MEMORANDUM ADDENDUM #1

TO: All Bidders
FROM: David Chen
DATE: June 6, 2025
RE: Pearl River Public Library – Complete Renovation Project

Pearl River Public Library – Complete Renovation Project

ADDENDUM NO. 1

1 FLOOR PLAN
1/4" = 1'-0"

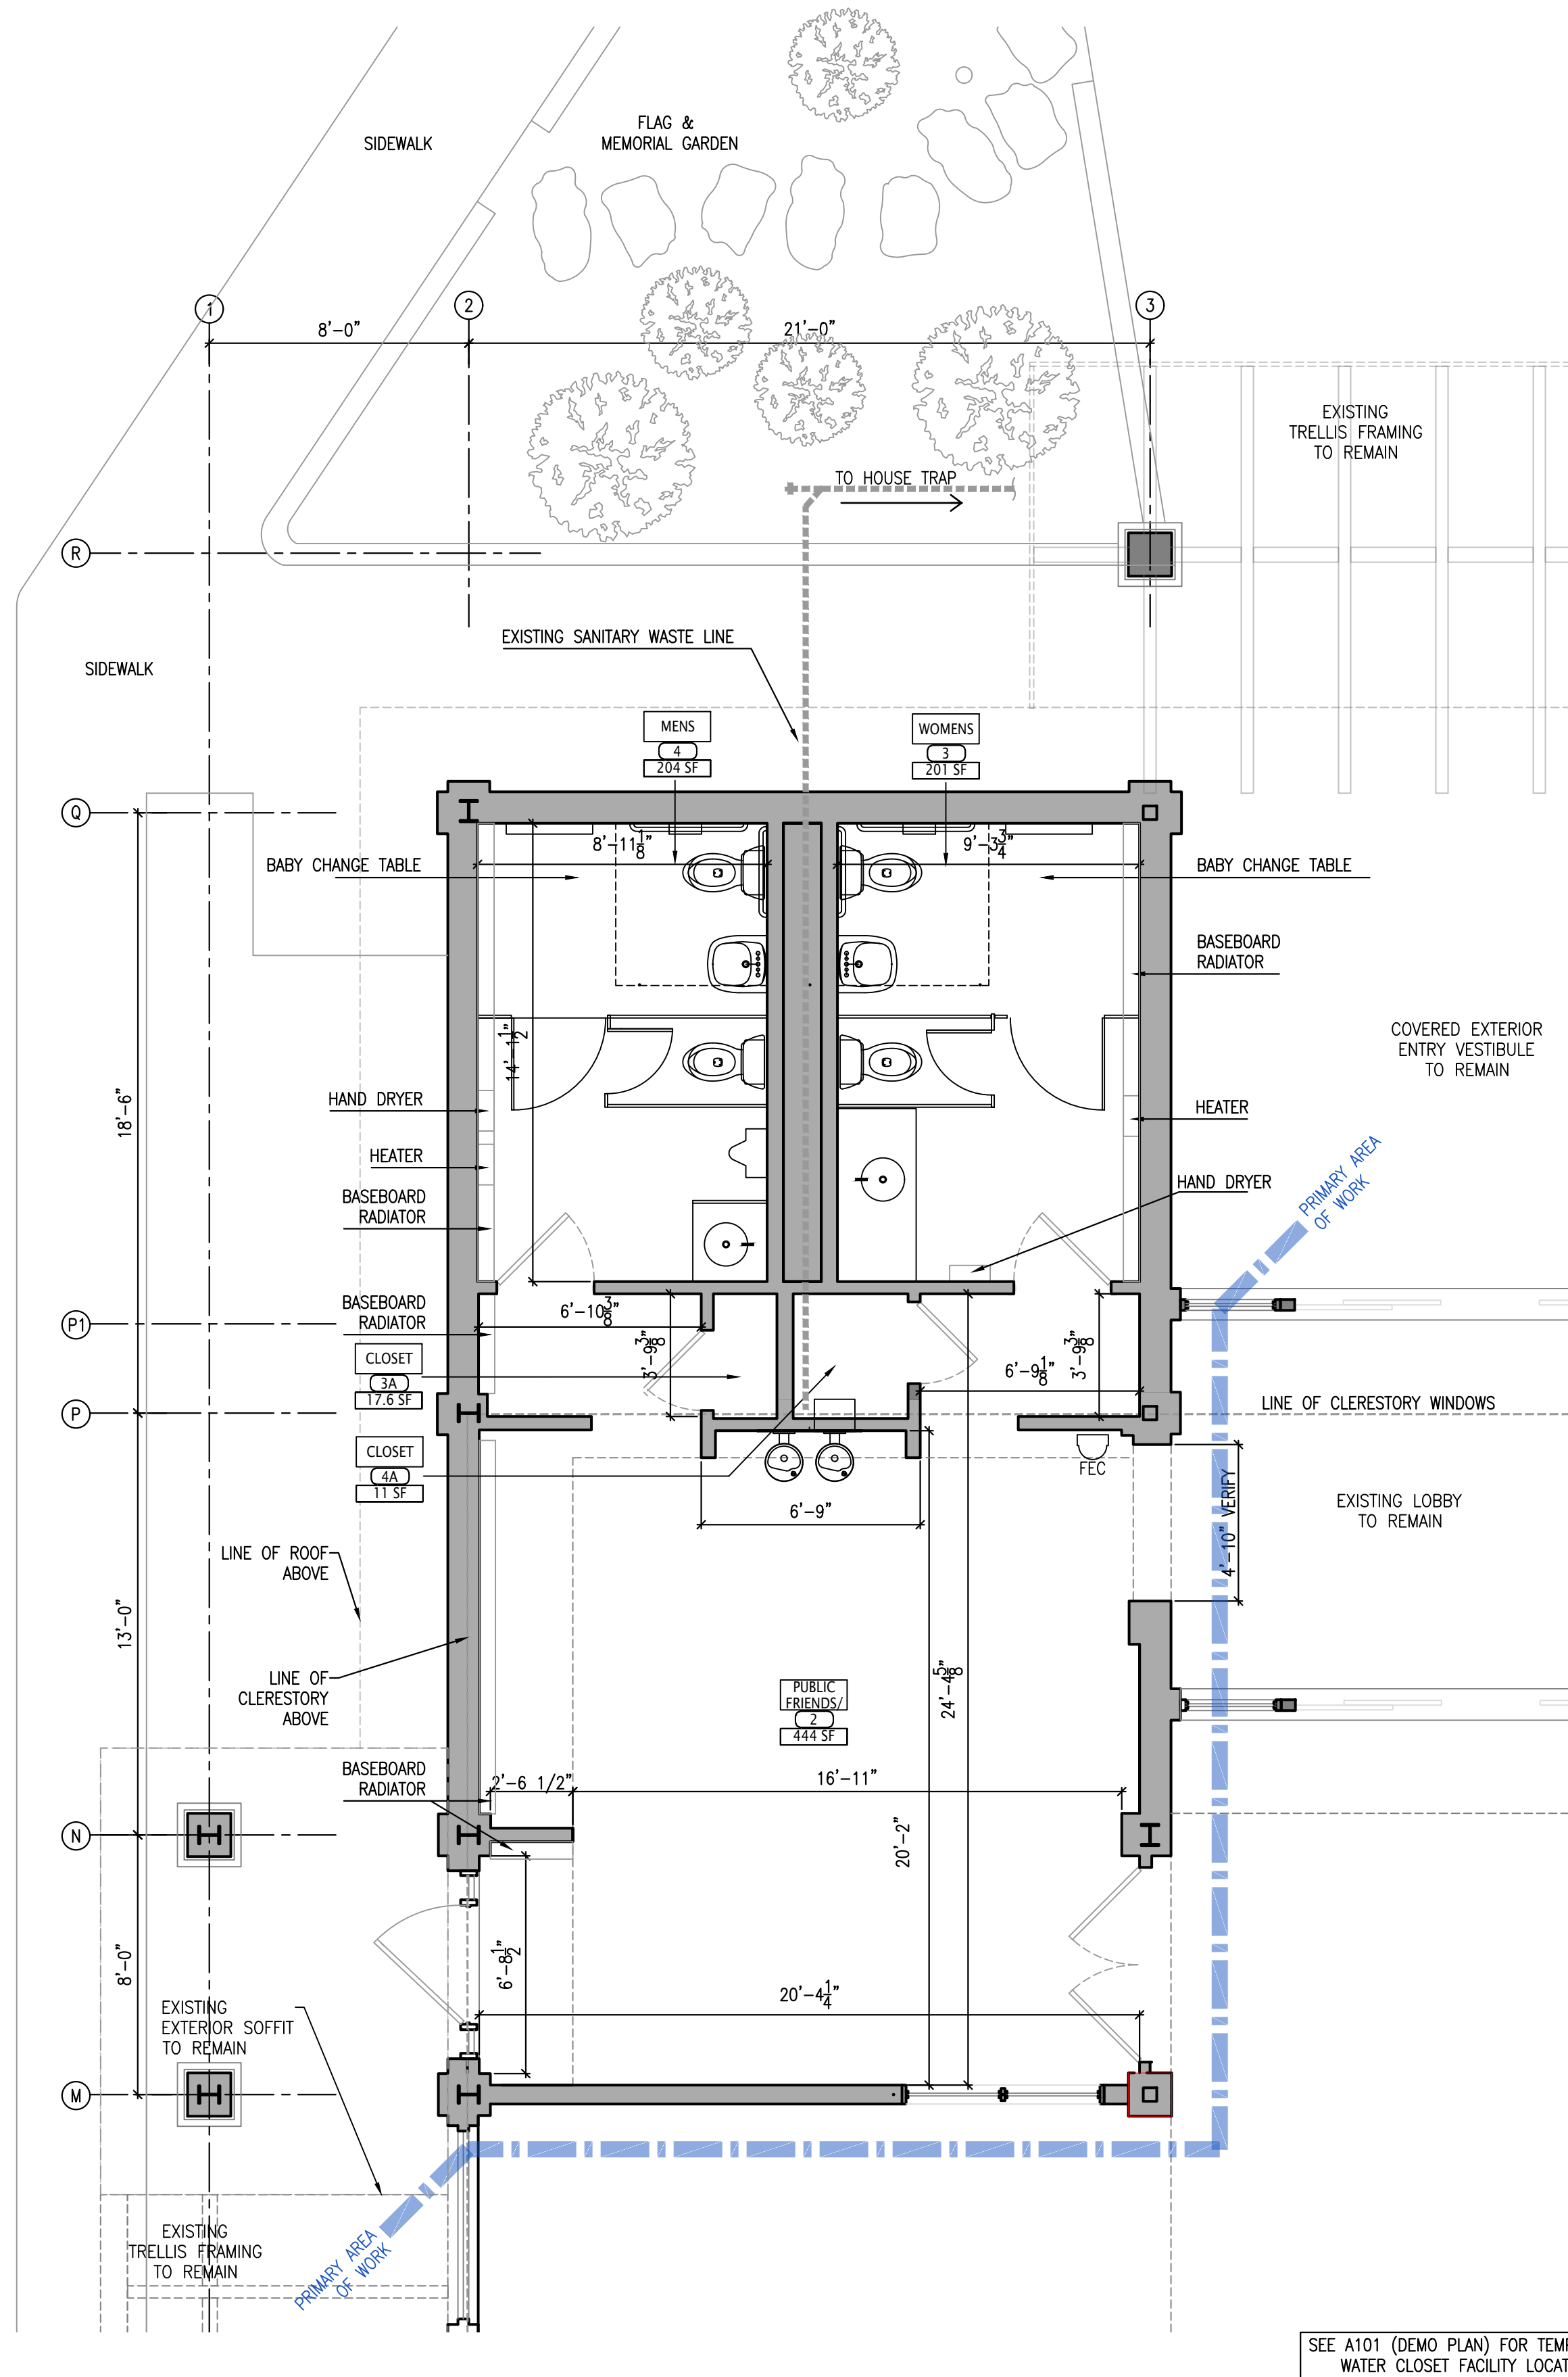
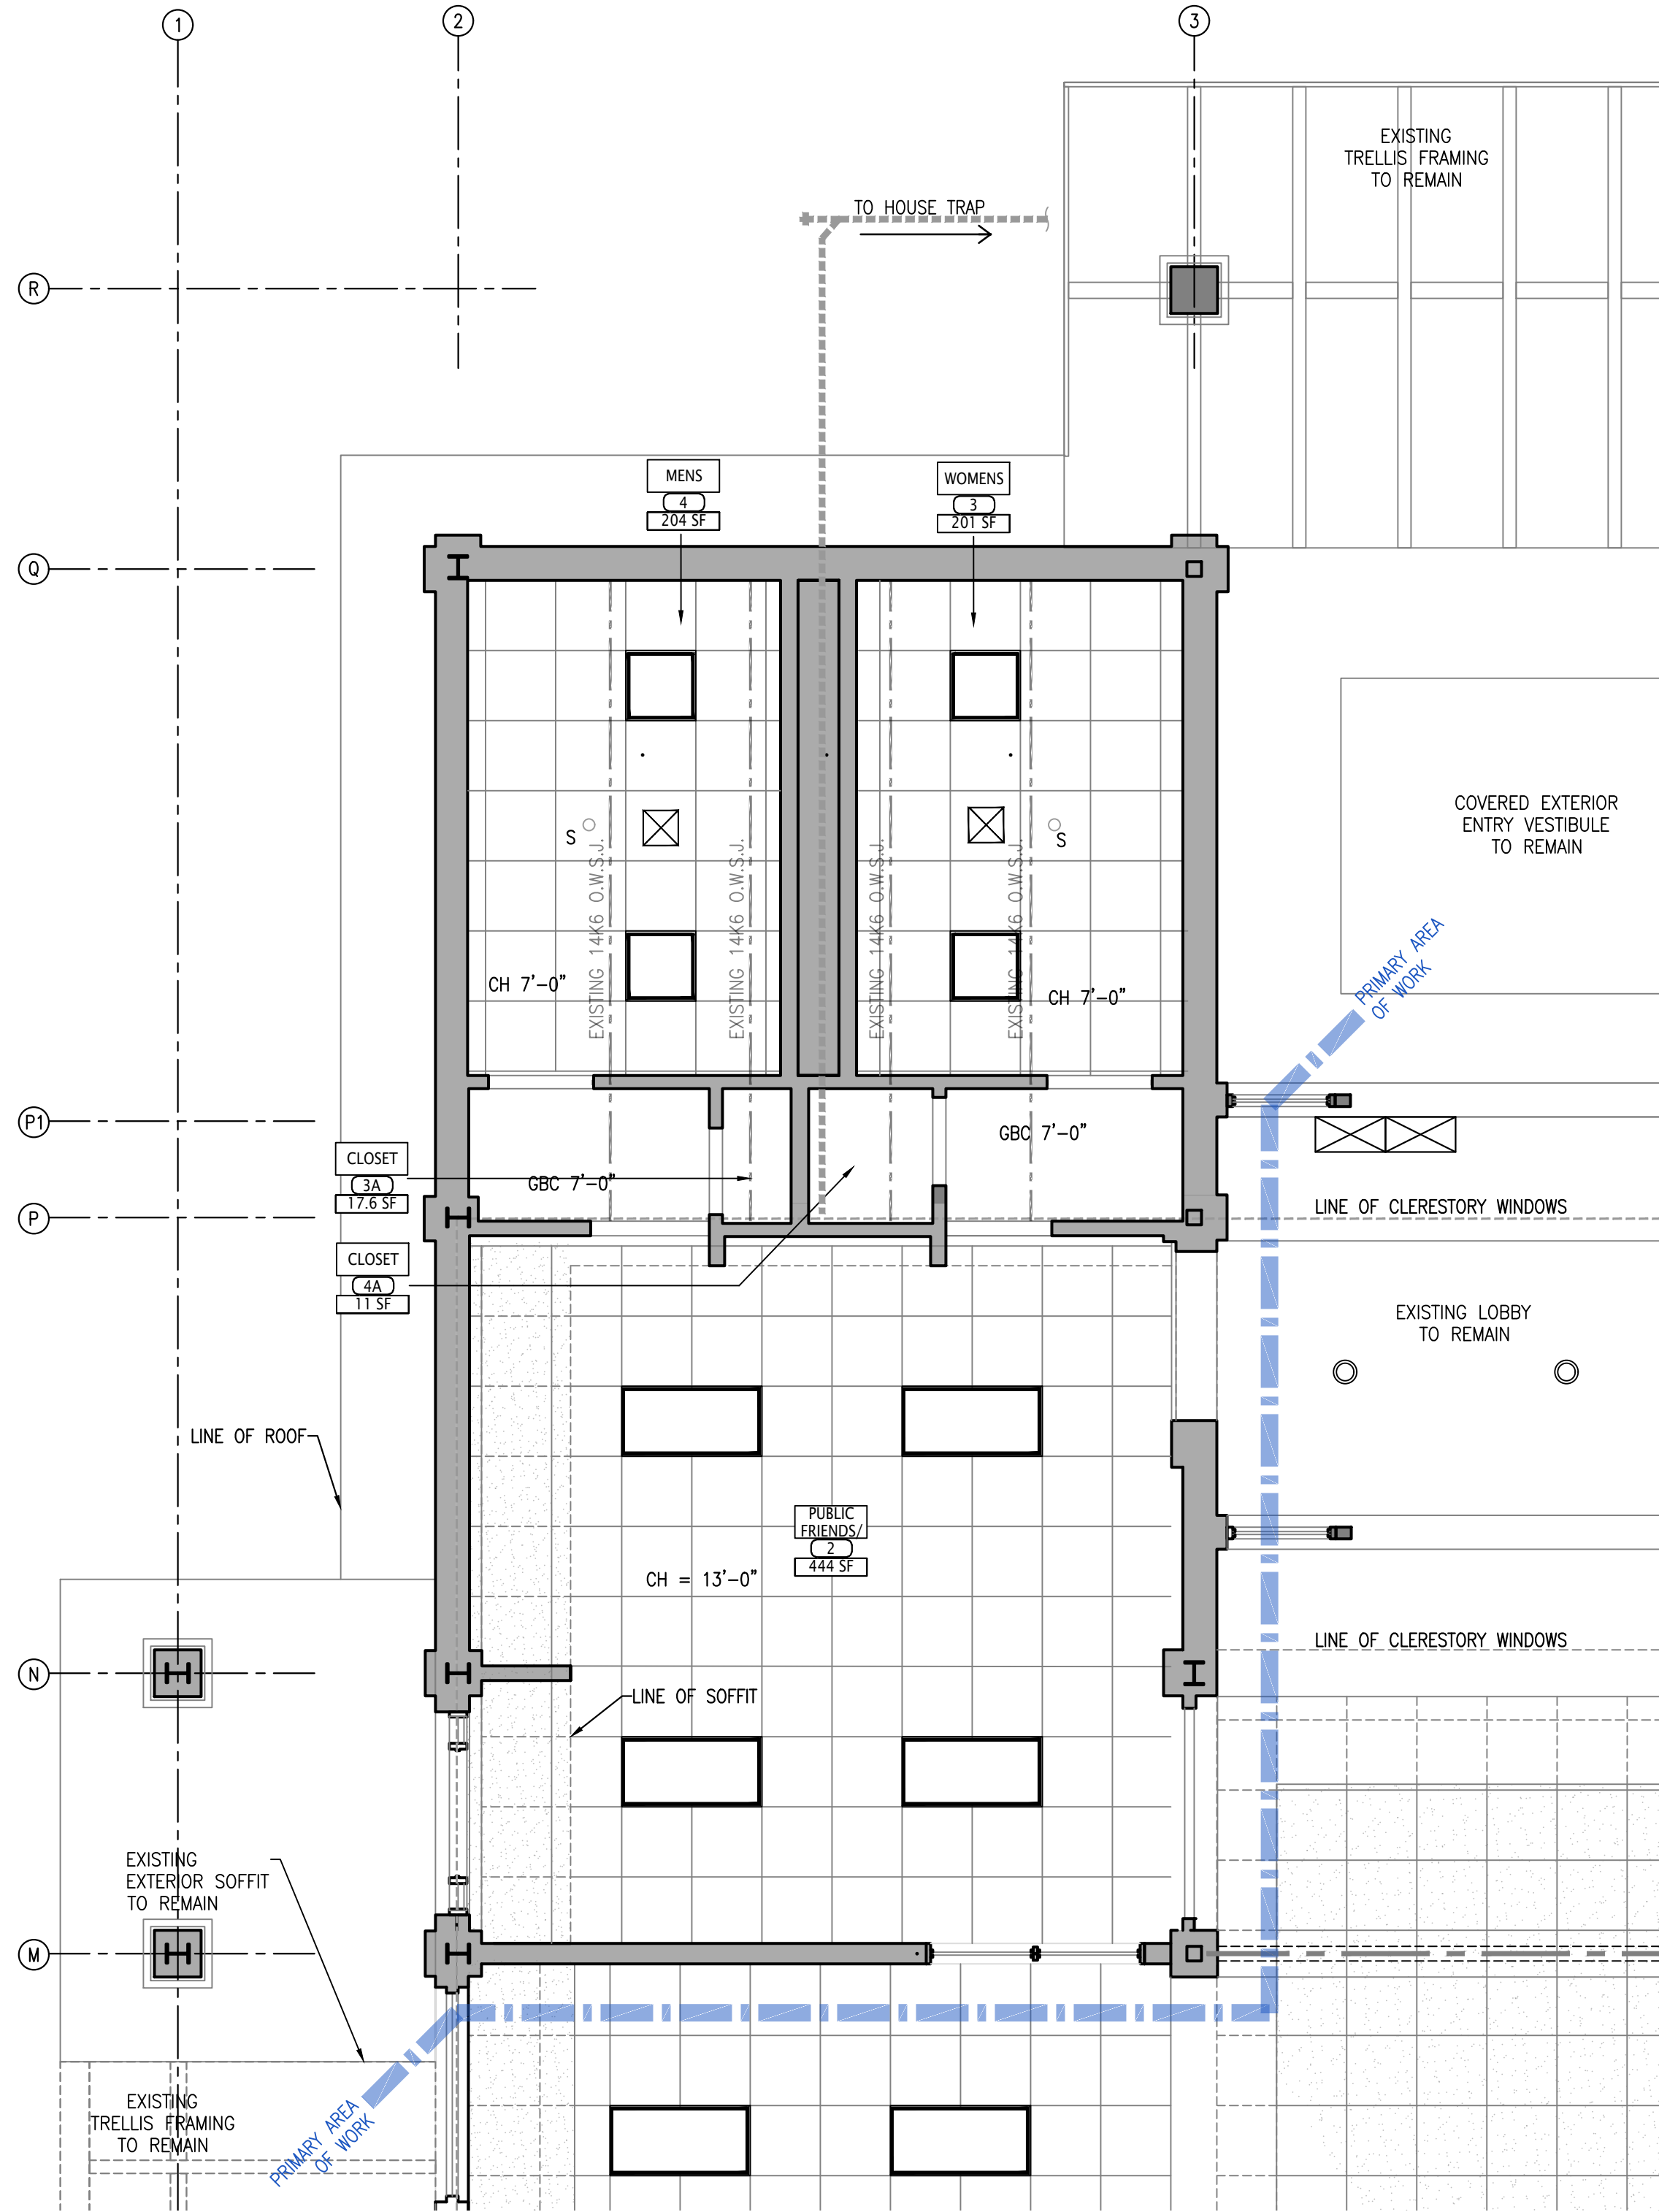
- a. **Response:** This is correct. Please review to the Alternate 3 Drawings and Alternate narratives in the Bid forms for scope.
8. **Question:** On the Restroom Renovation bid set drawing A002 and A101 are missing. Additionally, there are two drawings label A100 (Existing Conditions & Floor 01 Over Reference Plan) Please advise.

- a. **Response:** See Superseded Restroom Renovation Set “2.1 - 2578-01_23_0602 - PRPL RESTROOM BID SET AR (14p) (ADDENDUM 1)” for sheets A002 and A101. Furthermore, on sheet A000, the drawing list indicates A101 sheet title as FLOOR 01 PLANS: DEMOLITION PLAN & RCP. Sheet A101 has been revised and indicates the sheet title as PHOTO KEY & DEMOLITION PLAN
